# Service Bulletin 32

(a) Service Bulletin No:	32
(b) Revision / Date	1 / 21 September 2021
(c) Title:	Quick Shut Off Valves on Duplex propane cylinders CB2901, CB2902, CB2903.

(d) Description:	Undersize CB437 flanged adaptors for Quick Shut-Off valves.
(e) Applicability:	All HAB TCs and AS 105 GD Airships EASA.AS.002 All HAB manufacturers

## SB32 Cylinder Torque Test

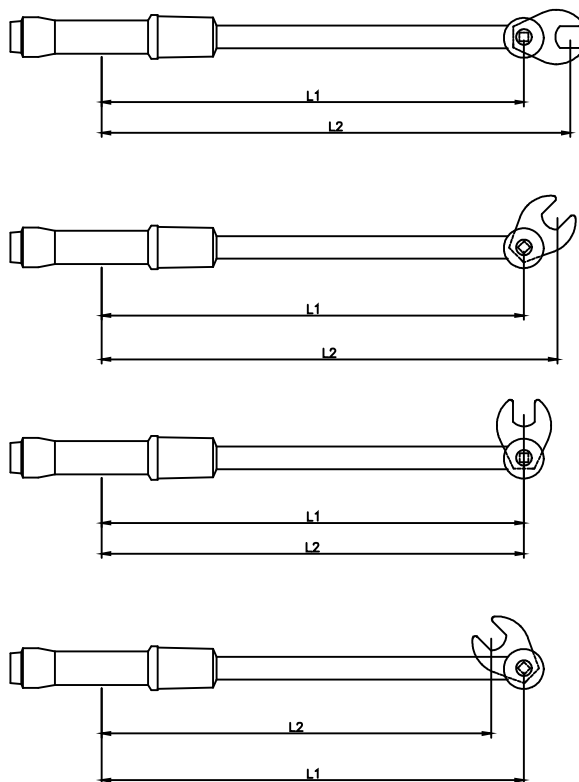
When you put an adaptor on a torque wrench (e.g. a 'Crow's Foot') that extends its length the torque applied to the fastener increases as the lever arm extends. This calculation will work out what value you should set into the wrench to achieve the required fastener torque.

Note that when the 'Crow's Foot' is at 90° to the torque wrench  $L1 = L2$ , so no correction factor is required.

$$M1 = M2 \times L1 / L2$$
